AMENDMENT TO FACILITY OPERATING LICENSE

Amendment No. 45
License No. NPF-8

SAFETY EVALUATION BY THE OFFICE OF NUCLEAR REACTOR REGULATION
RELATED TO AMENDMENT NO. 54 TO FACILITY OPERATING LICENSE NO. NPF-2
AND AMENDMENT NO. 45 TO FACILITY OPERATING LICENSE NO. NPF-8

JOSEPH M. FARLEY NUCLEAR PLANT, UNIT NOS. 1 AND 2

Figure 6.2-2 Facility Organization

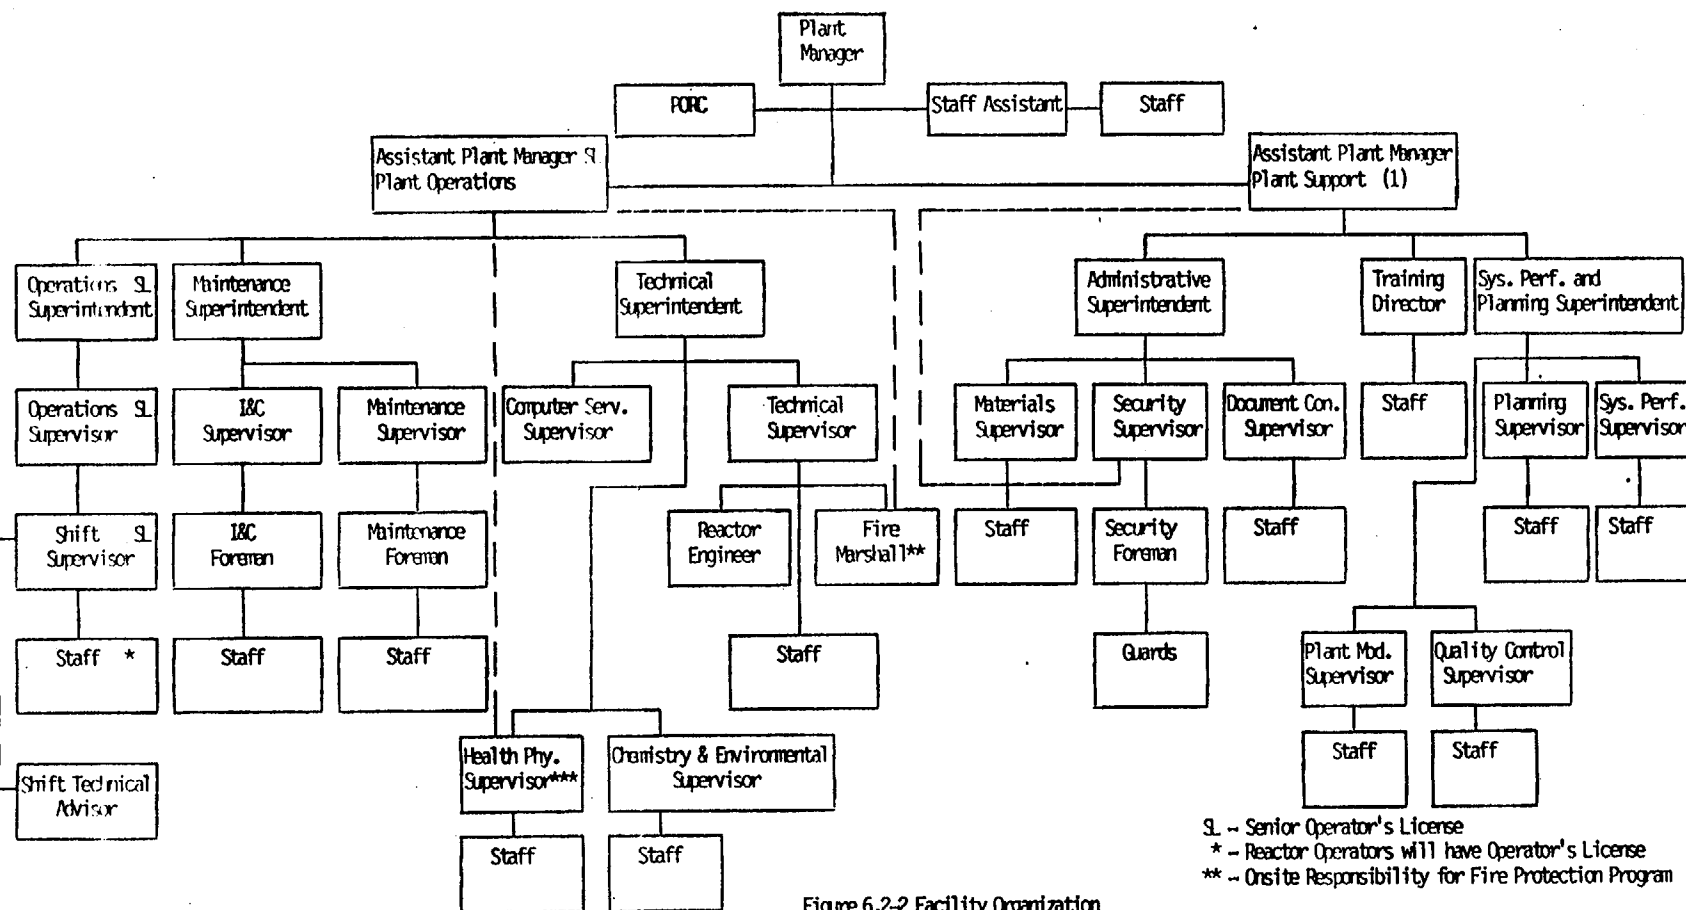
The amendments modify the Technical Specifications, Section 6, Administrative Controls, to reflect two Assistant Plant Managers; one responsible for overall plant operations and the other responsible for overall plant administration.

Following discussions between the Commission staff and the APCo staff the licensee proposed a clarification by letter dated September 24, 1984 to the staffing table in Figure 6.2-2 of the Technical Specifications to add a footnote #1 referencing the Assistant Plant Manager-Plant Support. Footnote #1 states that "The person filling this position may act as the Plant Manager, provided this person meets the requirements of ANSI N18.1-1971 Section 4.2.1, FSAR Section 13.1.3.1.1, and has completed Emergency Director Training." In addition, the licensee has agreed to amend the Farley FSAR and plant procedure references to the Assistant Plant Manager assuming responsibility for normal or emergency plant operations, or replacing the Plant Manager, to normally specify Assistant Plant Manager-Plant Operations, an SRO licensed position.

As specified in the September 24, 1984, clarification letter, the Assistant Plant Manager-Plant Support may also occasionally fulfill these responsibilities provided he meets all of the requirements specified in Footnote #1 of Technical Specification 6.2.2. The FSAR amendments have already been initiated by the licensee per 10 CFR 50.59, and the procedure modifications should be completed within 30 days after approval of these licensing amendments.

(1) The person filling this position may act as the Plant Manager, provided this person meets the requirements of ANSI N18.1-1971 Section 4.2.1, FSAR Section 13.1.3.1.1 and has completed Emergency Director Training.
